The Street – Suggested
Road Safety
Improvements

Suggested Improvements

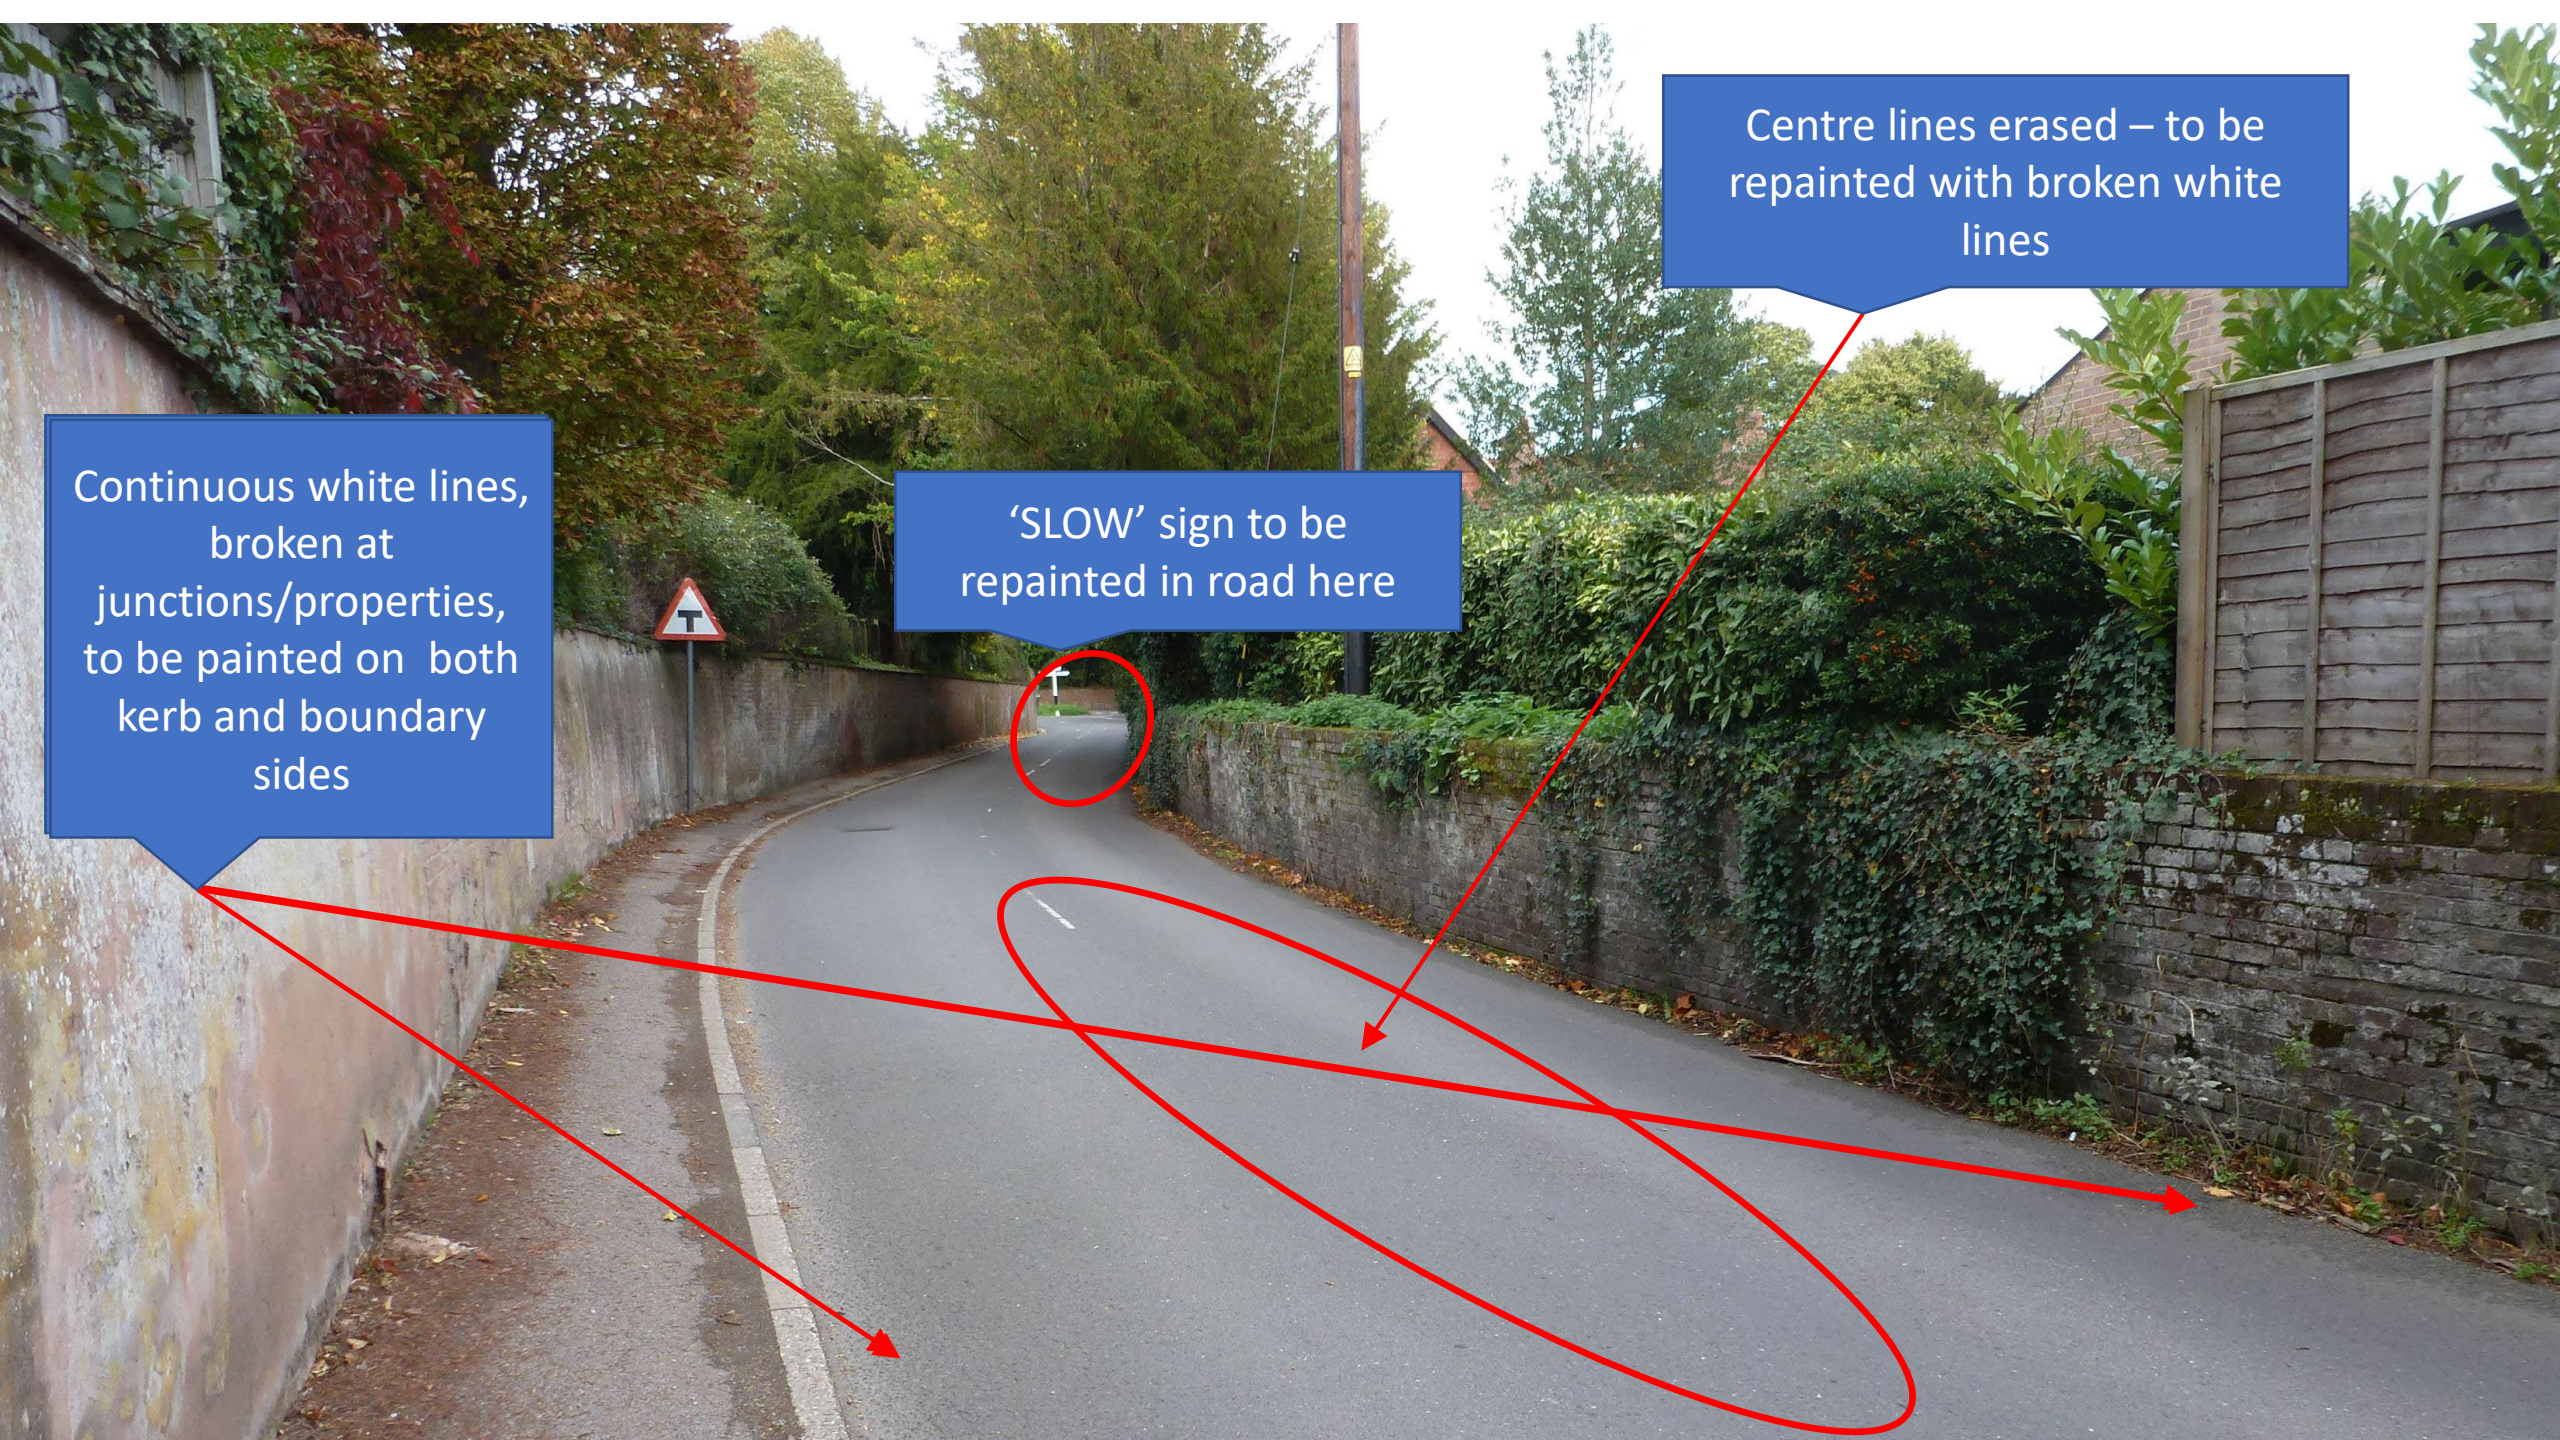
Improve warning approach signs near school with replacement larger sign on embankment, yellow background & trim foliage for visibility . Additional school approach signs coming from north end of road.

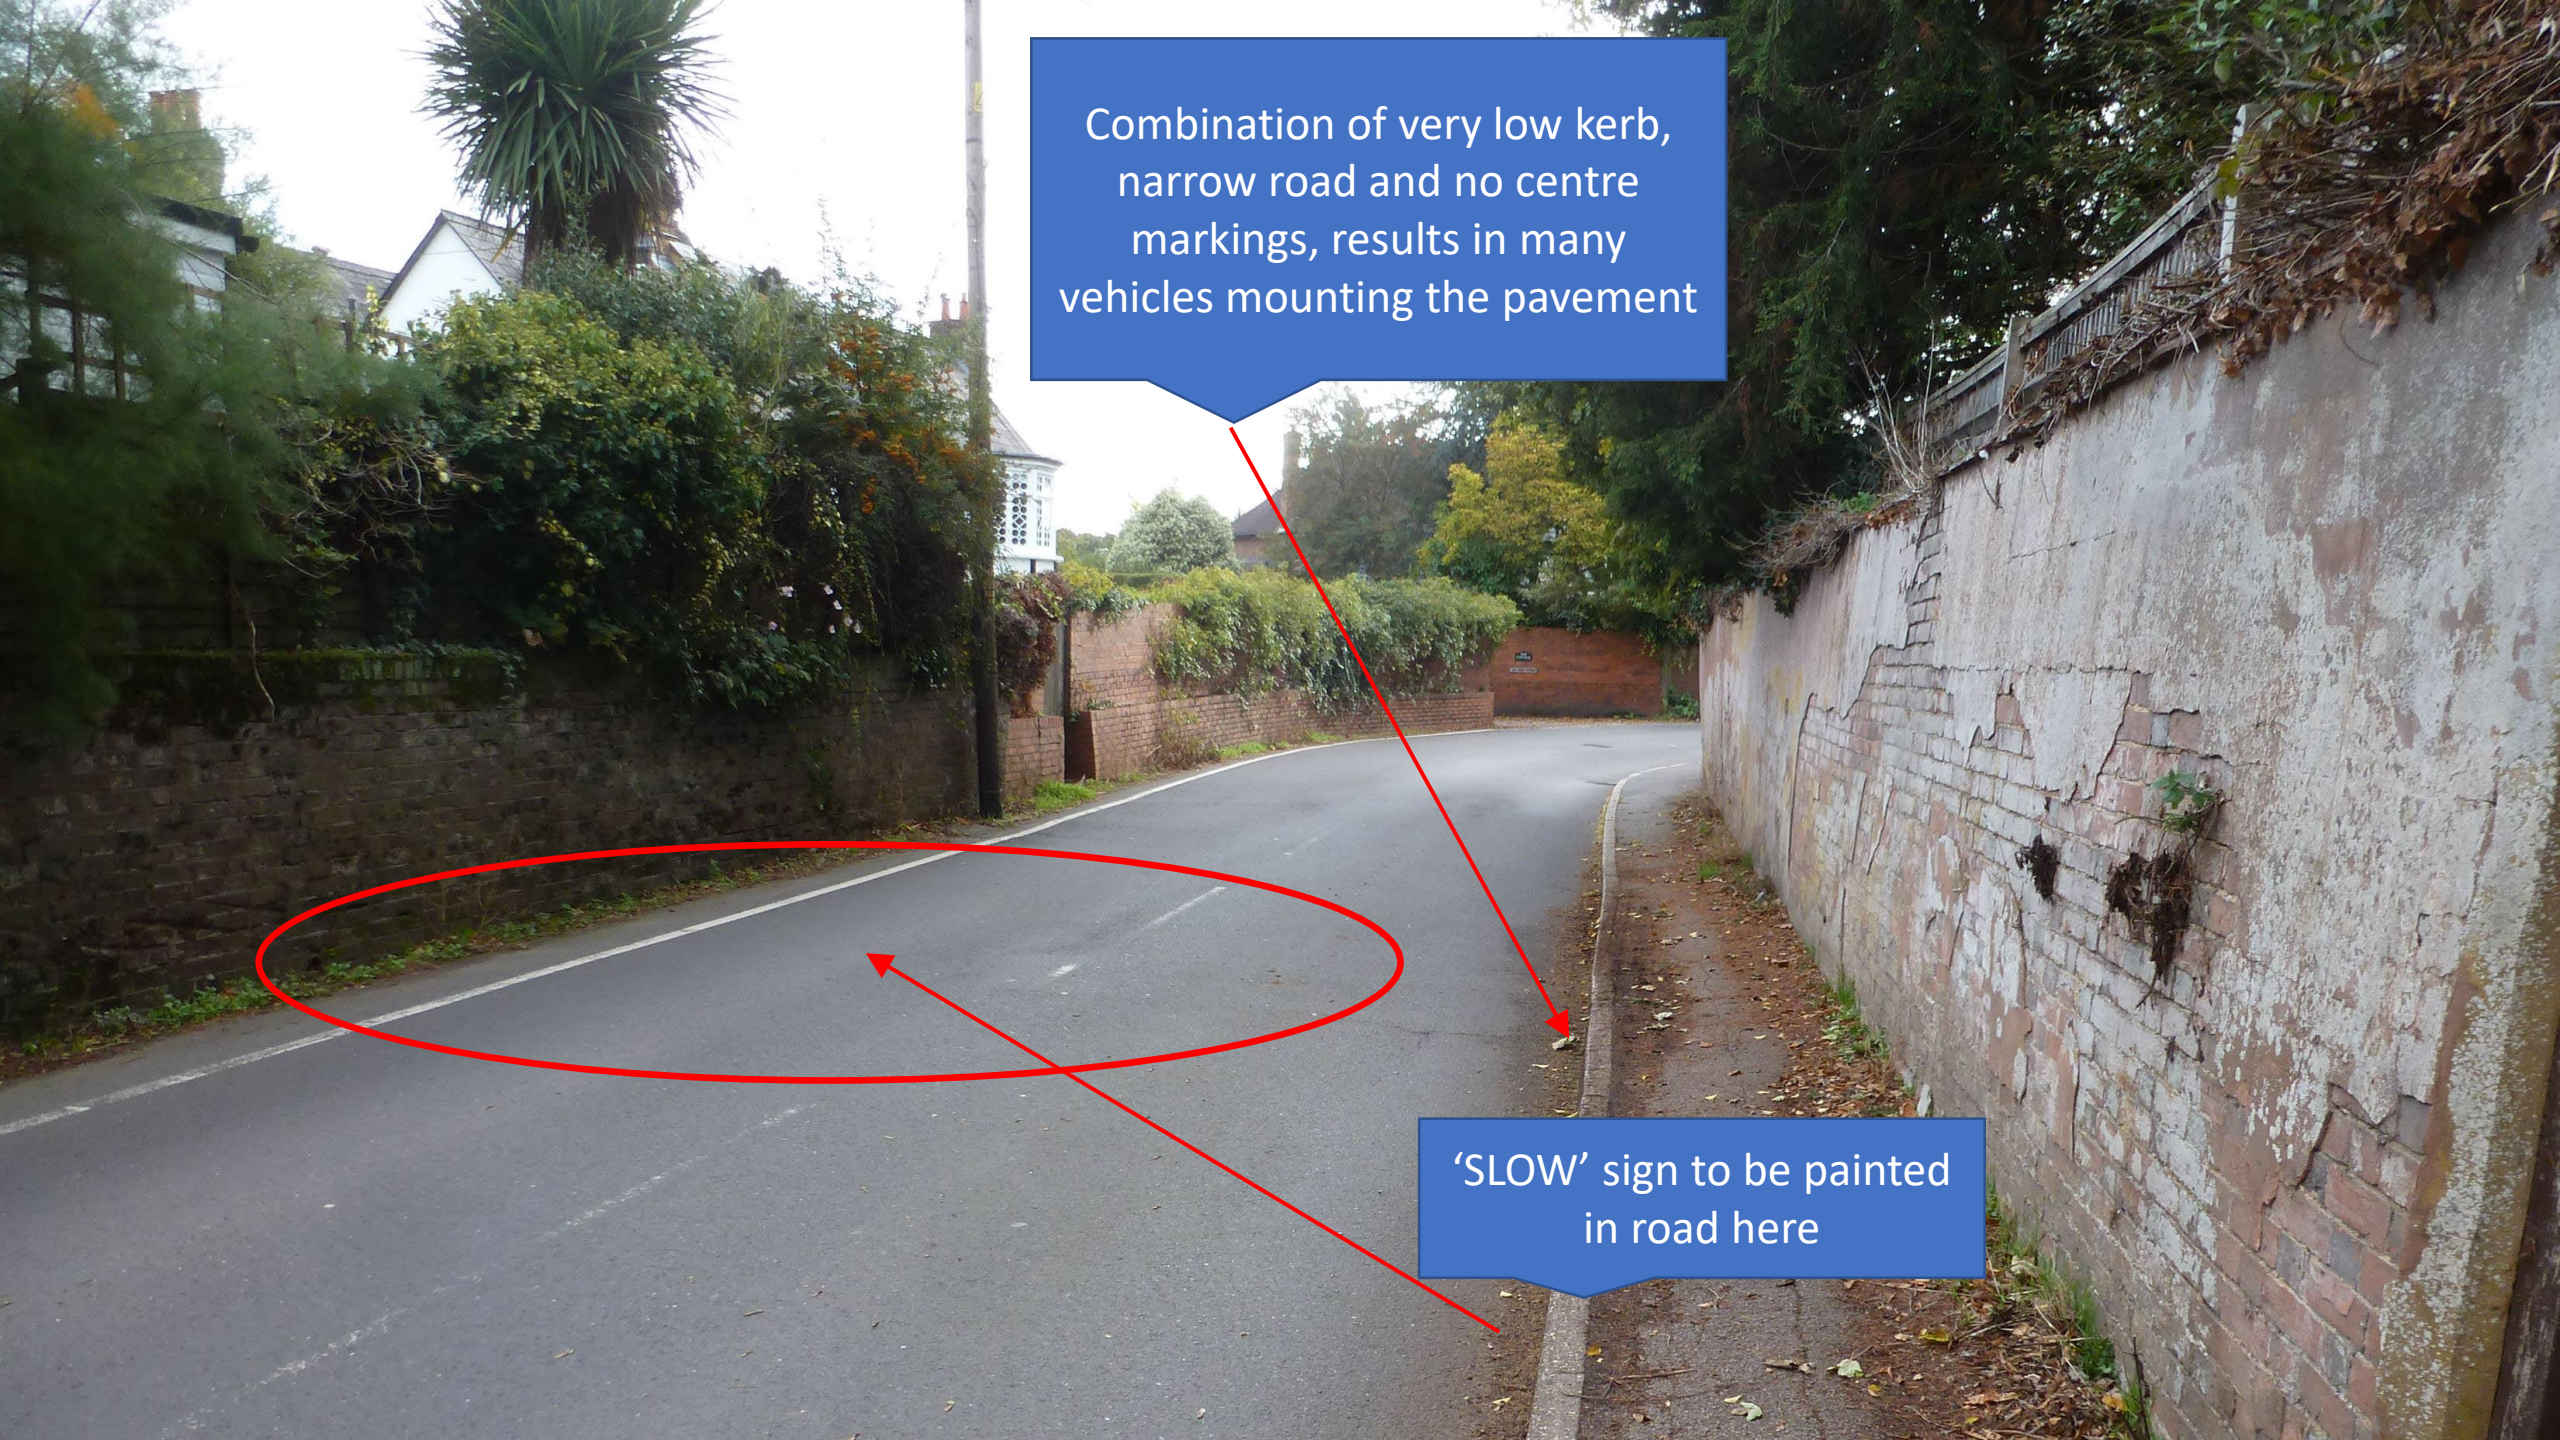
Renew all faded yellow cross hatching on road outside school.

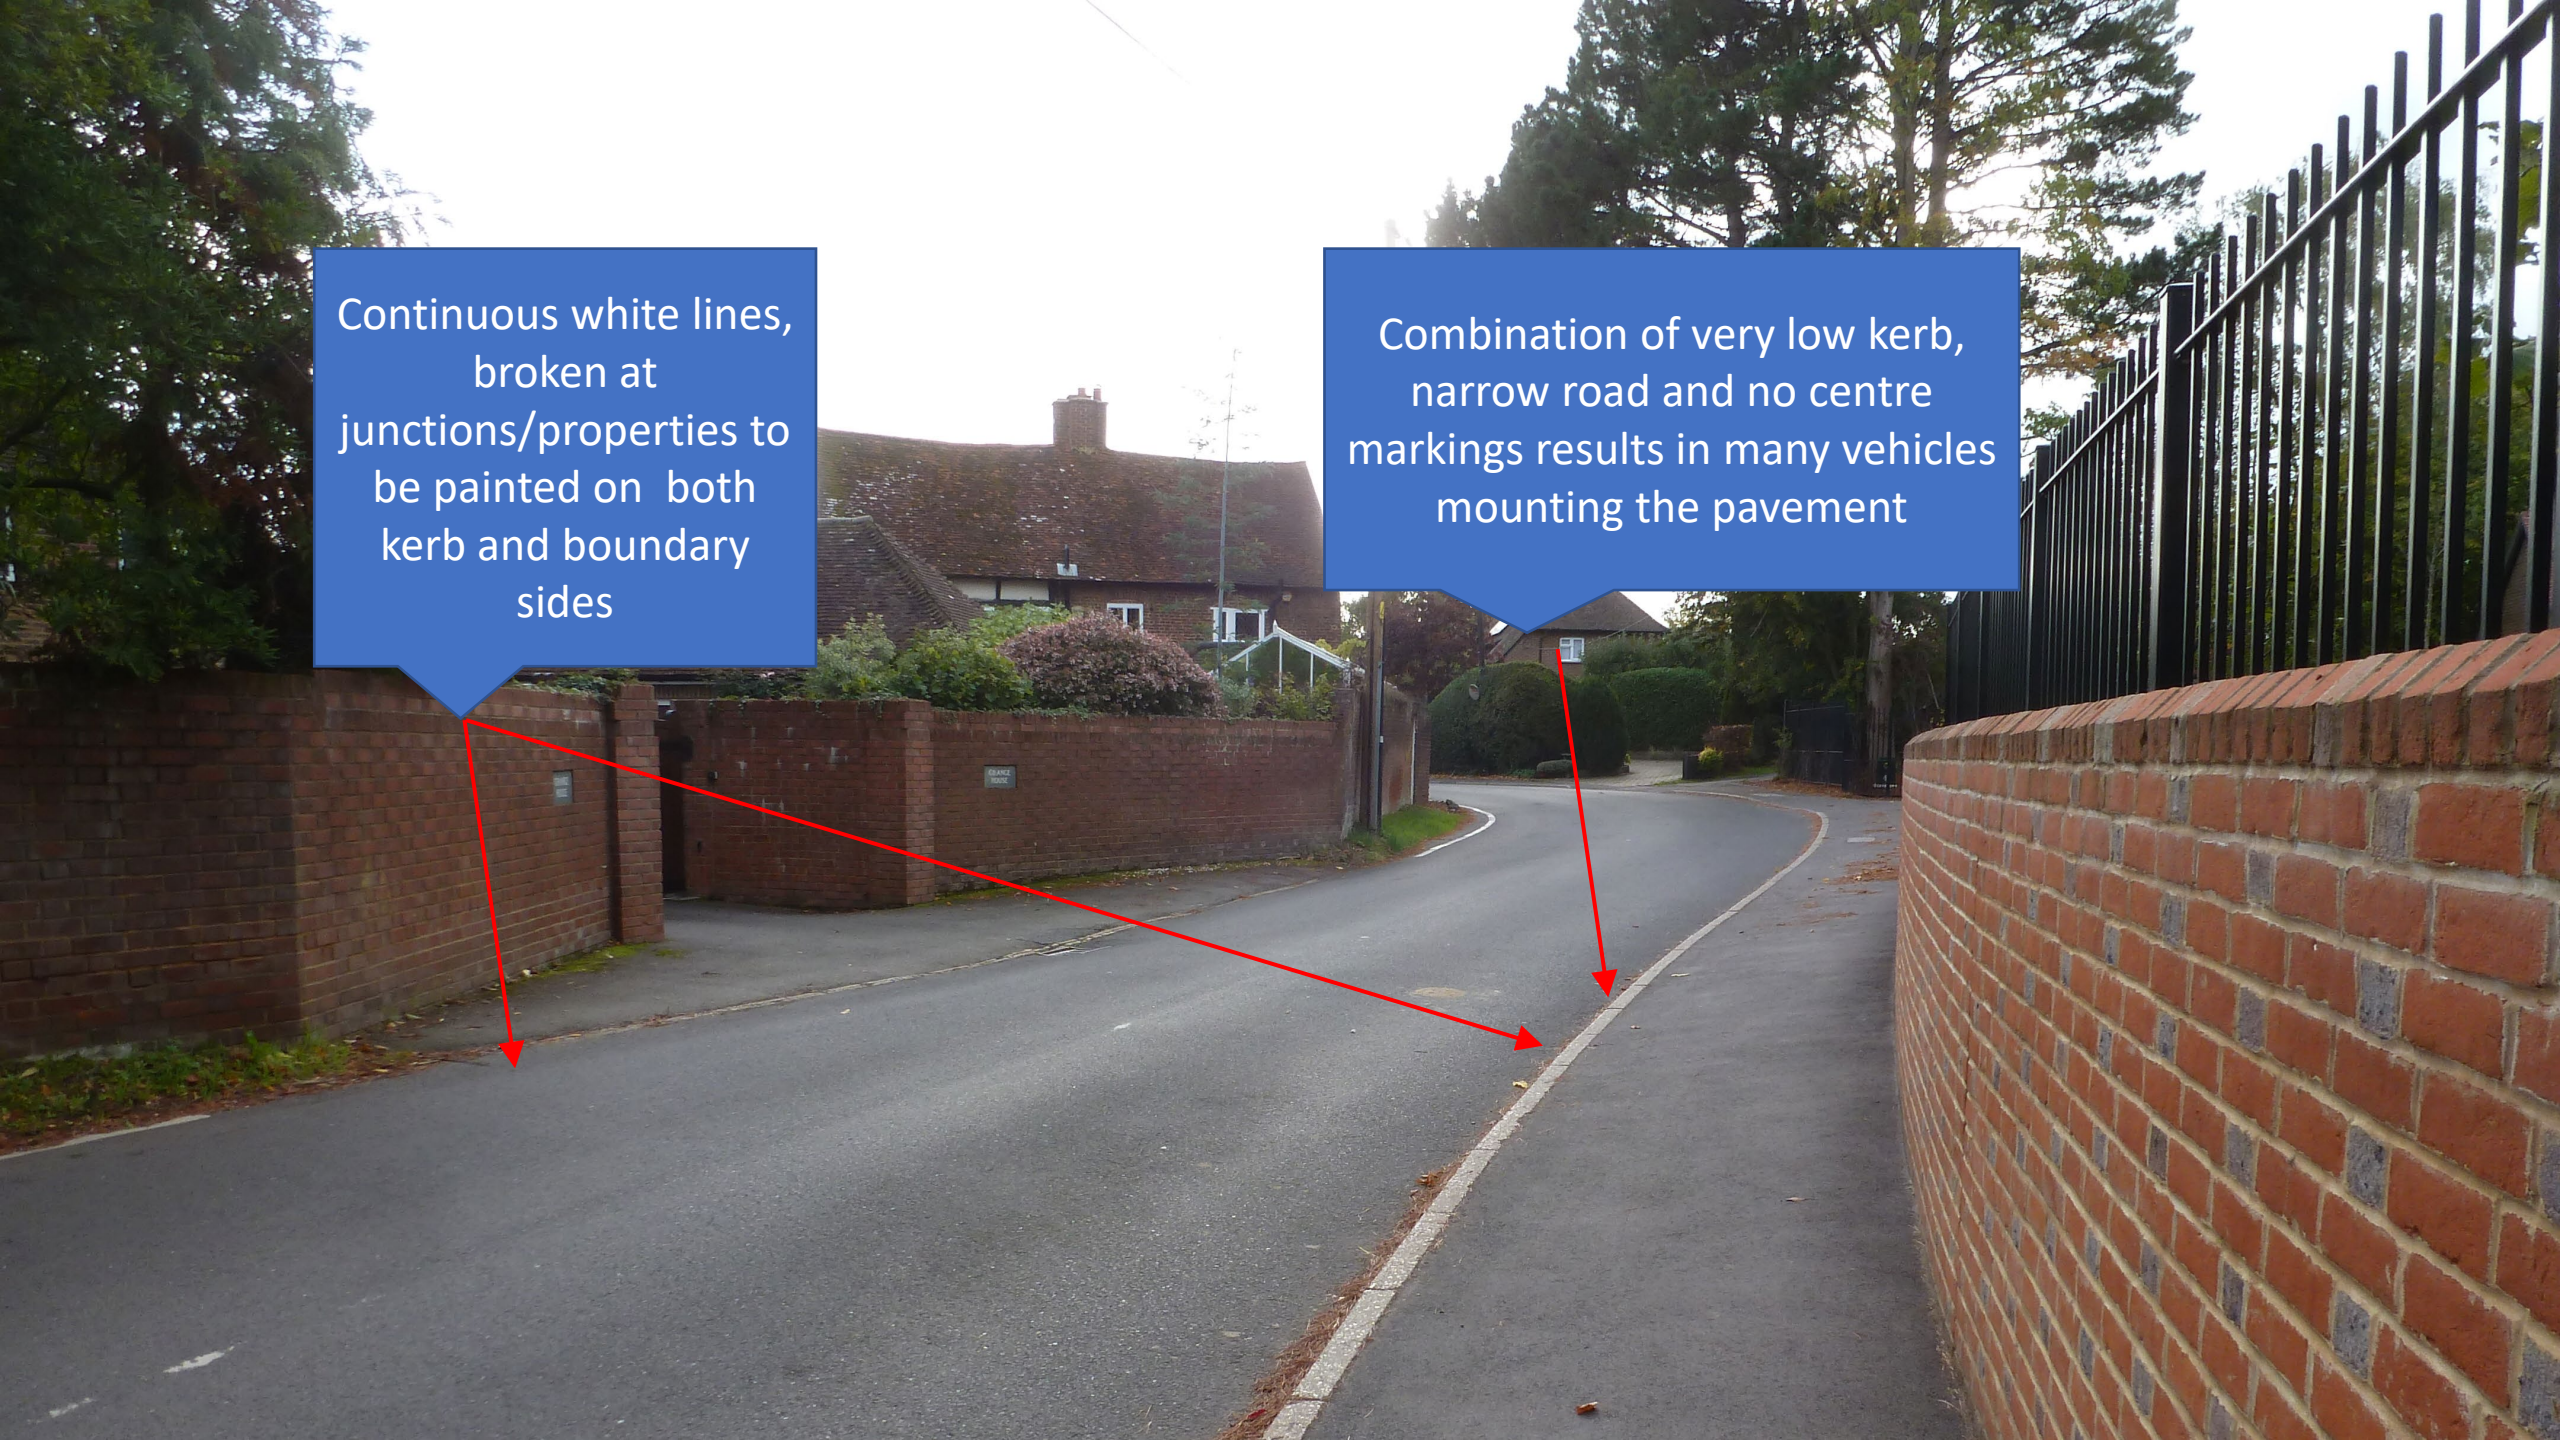
Continuous white lines,
broken at
junctions/properties,
to be painted on both
kerb and boundary
sides

'SLOW' sign to be
repainted in road here

Centre lines erased – to be
repainted with broken white
lines

Combination of very low kerb,
narrow road and no centre
markings, results in many
vehicles mounting the pavement

'SLOW' sign to be painted
in road here

Continuous white lines,
broken at
junctions/properties to
be painted on both
kerb and boundary
sides
